ORDINANCE 99-17

TO AMEND THE PRELIMINARY PLAN FOR PARCEL H OF THE CANADA FARM PLANNED UNIT DEVELOPMENT (PUD)
Re: 3809 South Sare Road
(Ken Blackwell, Petitioner)

Subject: Case # PUD-10-99

BLOOMINGTON PLAN COMMISSION
FINAL REPORT
LOCATION: 3809 South Sare Rd.

SITE PLAN IN CONTEXT WITH PUD

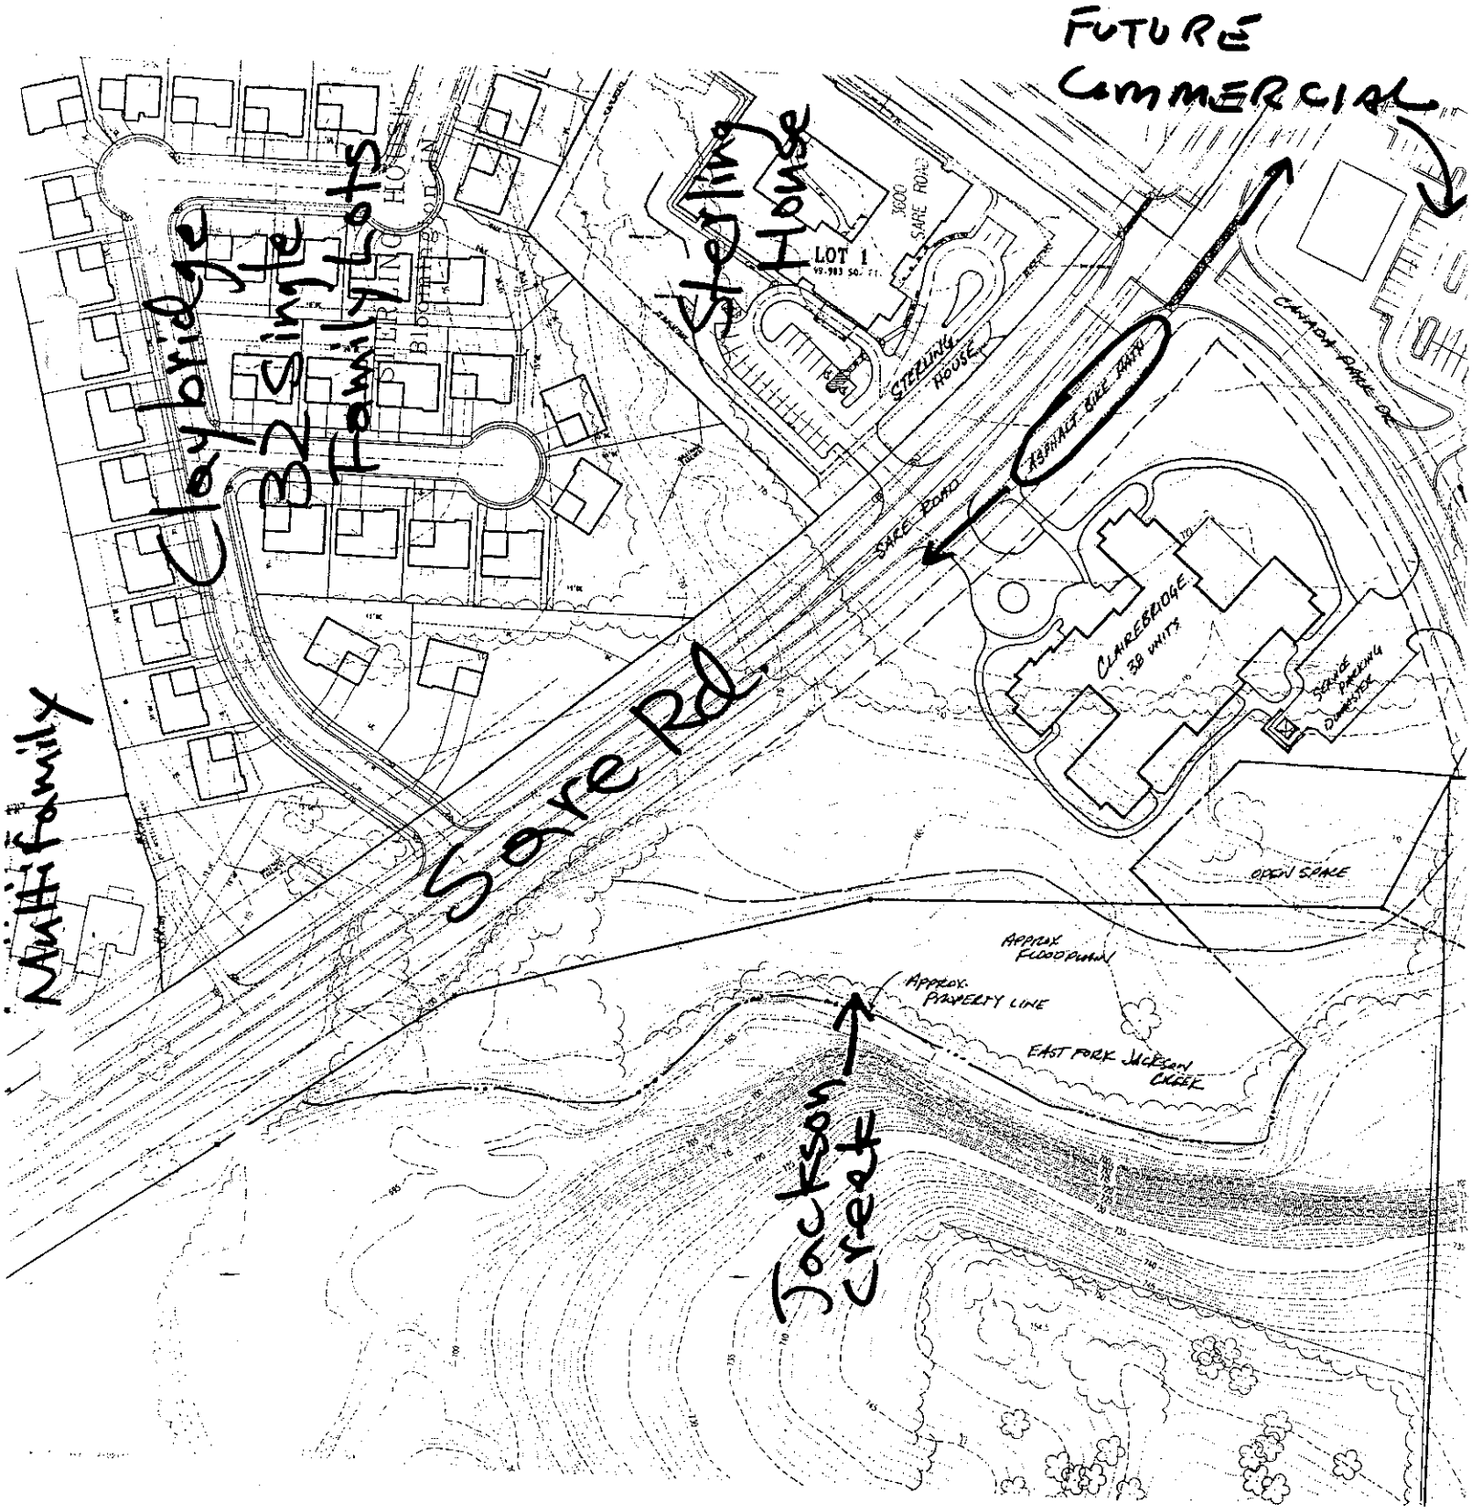
a. Elimination of two proposed single family units: Per staff's request, the two single family homes have been eliminated from the preliminary site plan.

c. Berming: As was done with the existing Sterling House facility, the petitioners will be installing a berm along the front setback with Sare Road to better screen the proposed drop-off area.

a. Elimination of the two single family units: Per staff's request, the two single family homes have been eliminated from the preliminary site plan.

c. Berming: As was done with the existing Sterling House facility, the petitioners will be installing a berm along the front setback with Sare Road to better screen the proposed drop-off area.

1. The two single-family homes will not be a part of this zoning amendment.

3. Earth berms with landscaping will be used to buffer entry drop-off zone and guest parking. A sample will be shown for the staff's review.

PUD-10-99
Site Plan Showing
Pathway

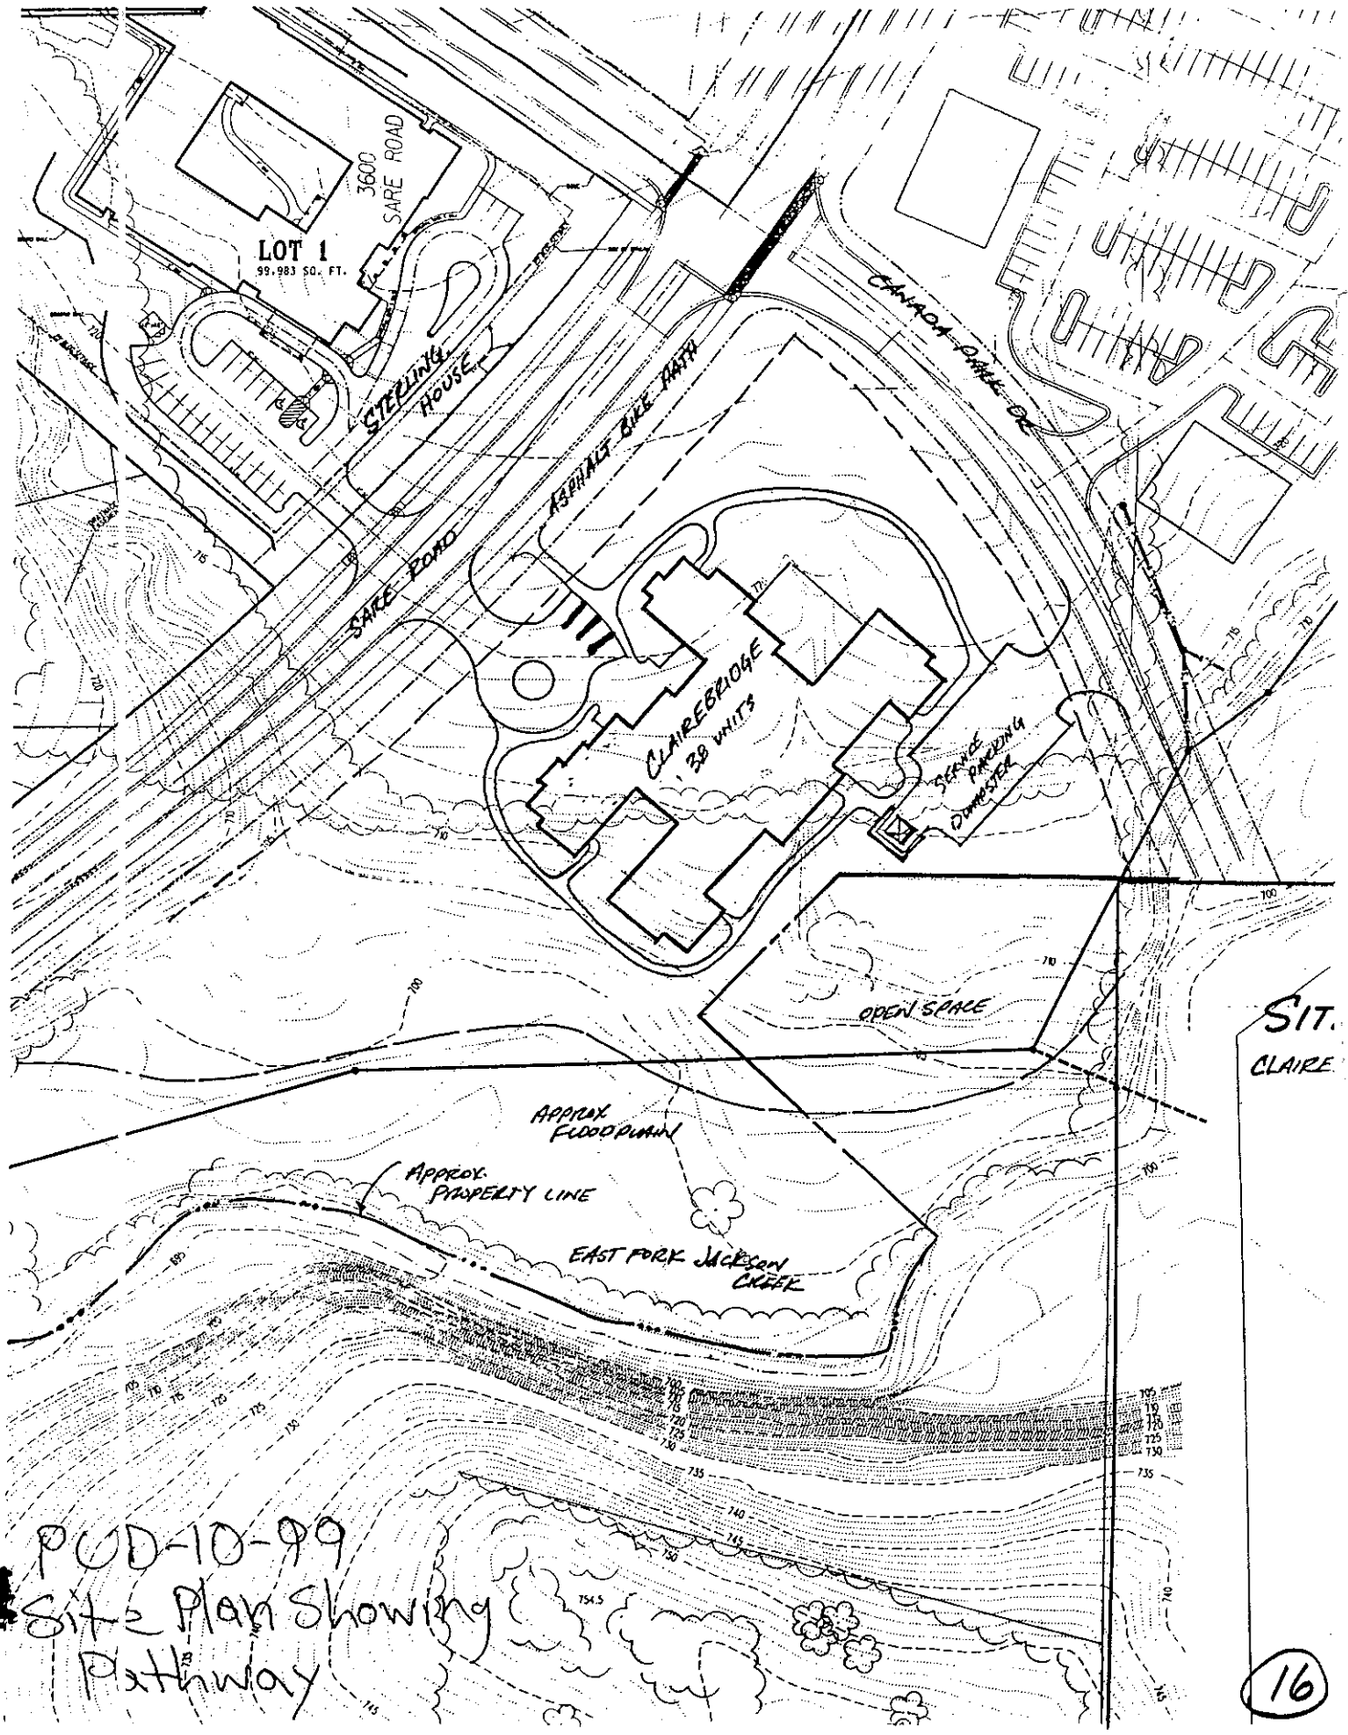
d. Pedestrian Accommodations: Per staff's request, the petitioner has designed a pathway system which will allow residents to walk around the perimeter of the building as well as enjoy the available open space at the rear of the property along the east fork of Jackson Creek.

d. Pedestrian Accommodations: Per staff's request, the petitioner has designed a pathway system which will allow residents to walk around the perimeter of the building as well as enjoy the available open space at the rear of the property along the east fork of Jackson Creek.

4. Based on the staff's recommendation, a pathway system around the site to the greenway system will be shown.
